### FASCIA @ EAVE

WHEELER STALLARD HOUSE  
EXTERIOR RENOVATION & REPAIRS

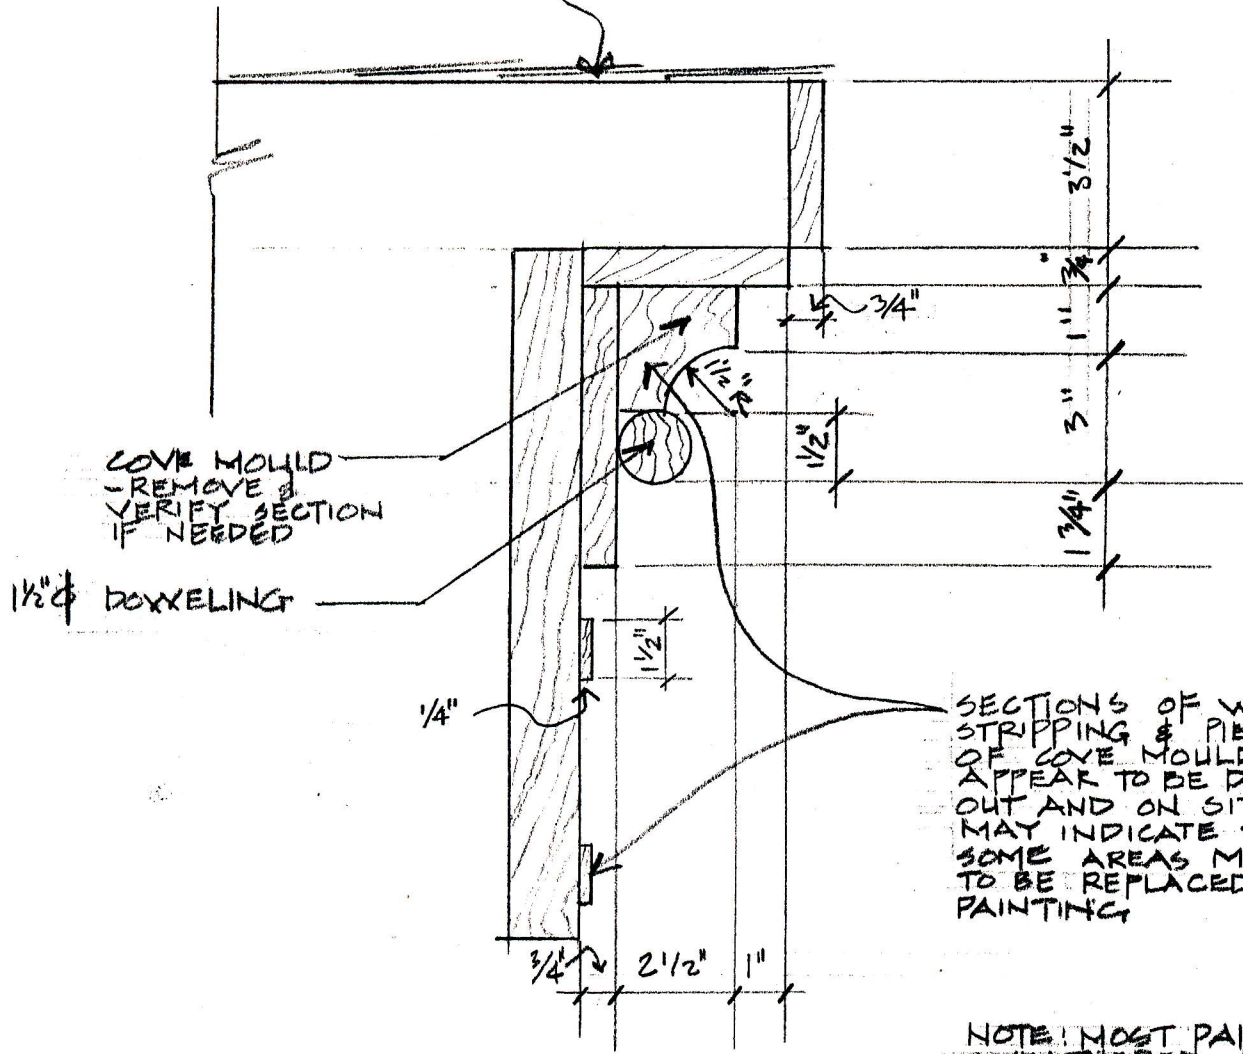
COVE MOLD  
- REMOVE &  
VERIFY SECTION  
IF NEEDED

SECTIONS OF WOOD  
STRIPPING & PIECES  
OF COVE MOULDING  
APPEAR TO BE DRY ROTTED  
OUT AND ON SITE INSPECTION  
MAY INDICATE THAT  
SOME AREAS MAY NEED  
TO BE REPLACED DURING  
PAINTING

NOTE: MOST PAINT HAS  
WEATHERED AWAY OR  
REMAINS IN LARGE FLAKES
